Introduction and make-up of A.P.4099G, Vol. 2, Part 1

1. Air Publication No. 4099G has been allotted to the Vampire F.B. Mk. 9 aircraft. The Vol. 2, Part 1, of the A.P. will contain General Orders and Modification leaflets, and will conform to the "Revised (1948) System for Recording Leaflets".

ARRANGEMENT OF TOTAL HEAD AIRLINE TO BAROSTAT.

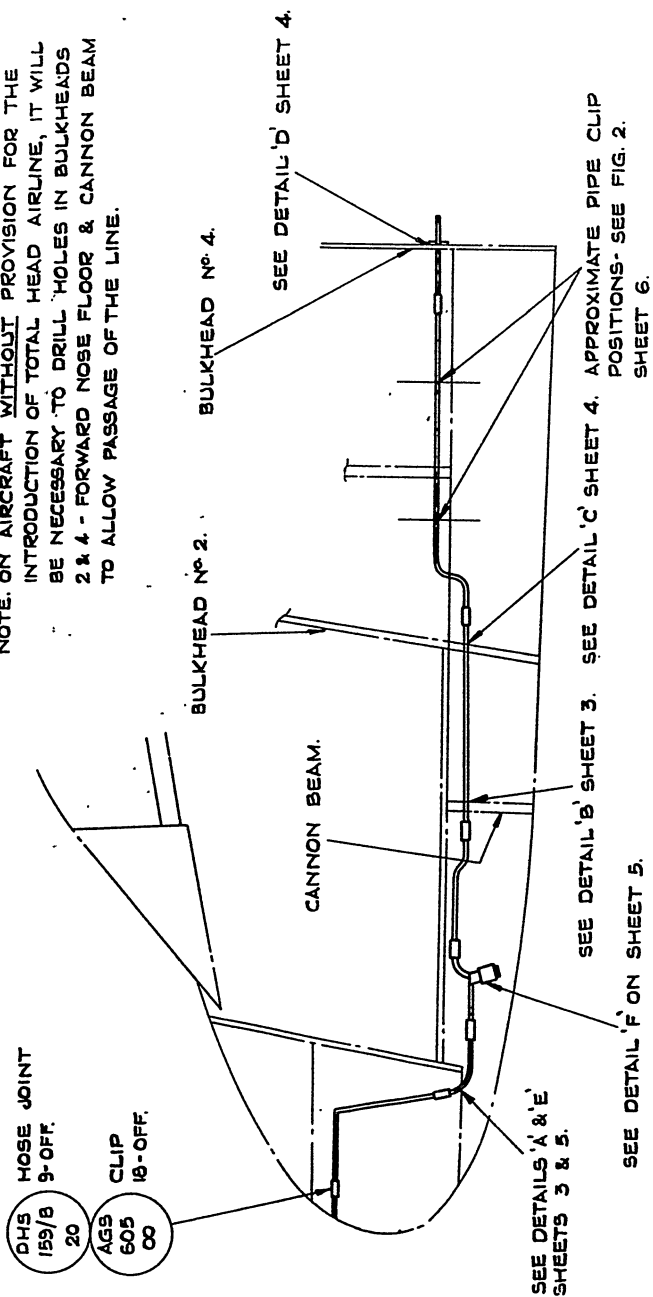
- (6) DRG. NO. A.P.4099G/J.13/53. SHEET 1. *Amend* "22 SWG." to read "26 SWG."

DRG. NO. A.P. 4099 G / J. 14 / 54  
SHEET 2

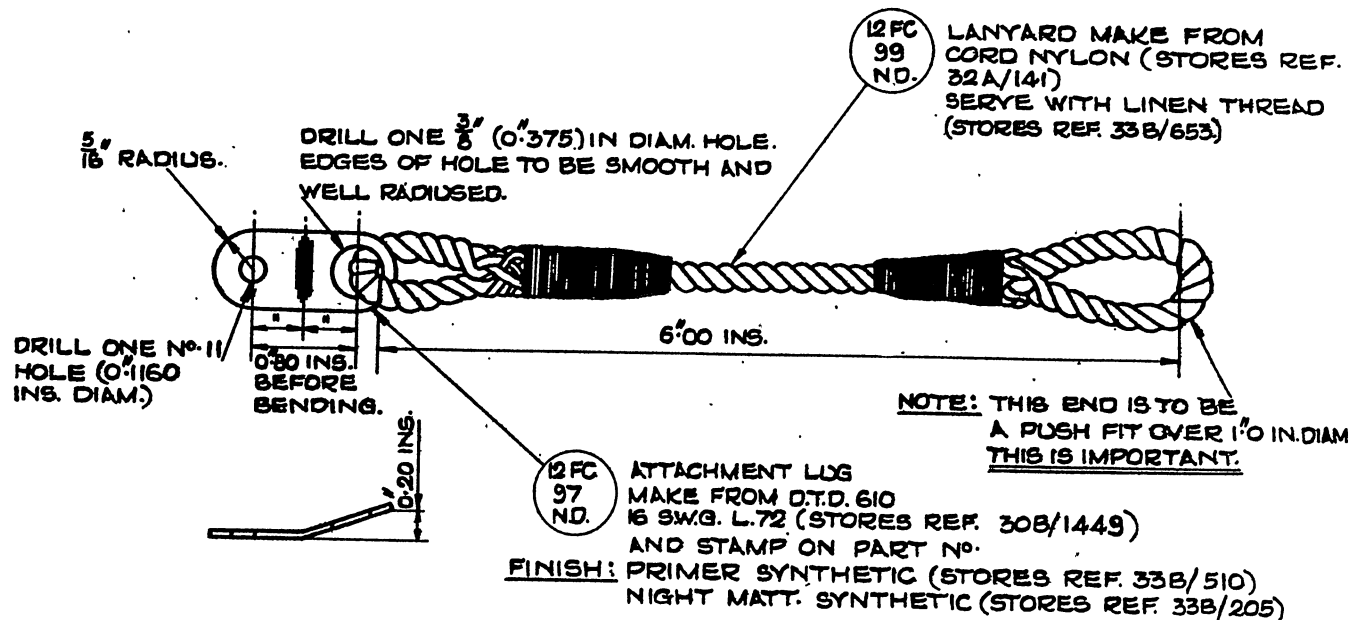
(2) Para. 8, operation (2), lines 2 and 3. *Delete* "cord, nylon (Stores Ref. 32A/141)" and *substitute* "cord, kite, 2 lb., Specification 4.F.32 (Stores Ref. 32A/10)".(3) DRG. NO. A.P.4099G/J.14/54, SHEET 2. In top R.H. corner. *Delete* "CORD NYLON (STORES REF. 32A/141)", and *substitute* "CORD, KITE, 2 LB. SPECIFICATION 4.F.32 (STORES REF. 32A/10)".**RESTRICTED**

FIG.2. REVISED WIRING OF JUNCTION BOX. JBI.

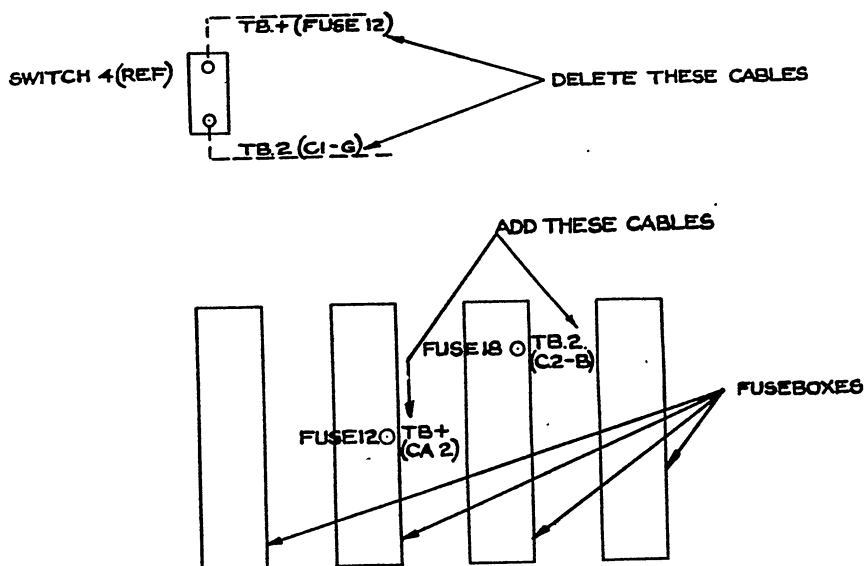
(5) DRG. NO. A.P.4099G/K.11/53. SHEET 2 in FIG. 2 *insert*  
"NOTE:—ON AIRCRAFT PRE MOD. NO. VAMPIRE/  
568 CONNECT FUSE 12 TO PIN Z OF PLUG C2 AND FUSE  
18 TO PIN 2 OF PLUG CZ."

DRG. N° A.P.4099 G/K.II/53  
SHEET 6

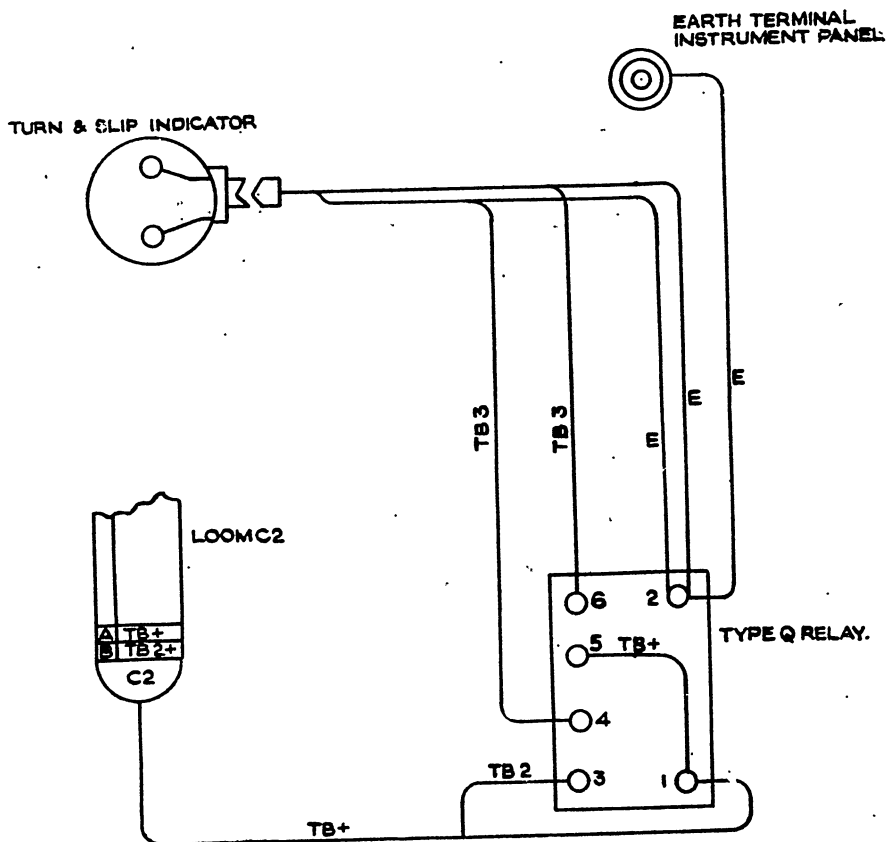
(7) DRG. NO. A.P.4099G/K.11/53. SHEET 6.
